Notice of Allowability

10/807,129

LIN, WEN-JIAN

EXAMINER'S AMENDMENT

FIG. 4D

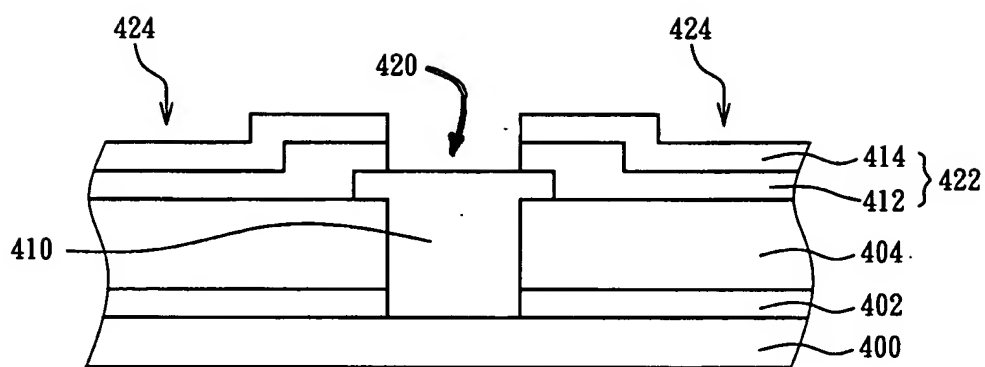
In the amended drawing sheet for Figure 4D, the arrow relating to element 420 was redirected to indicate the space, as opposed to the top layer (the layer is already labeled as 414). These changes were necessary to more properly coincide with the description of the invention, i.e. avoid confusion.

4. New corrected drawings in compliance with 37 CFR 1.121(d) are required in this application because of the indicated change made to Figure 4D. Applicant is advised to

In order to avoid abandonment of the application, applicant must make these above drawing changes.
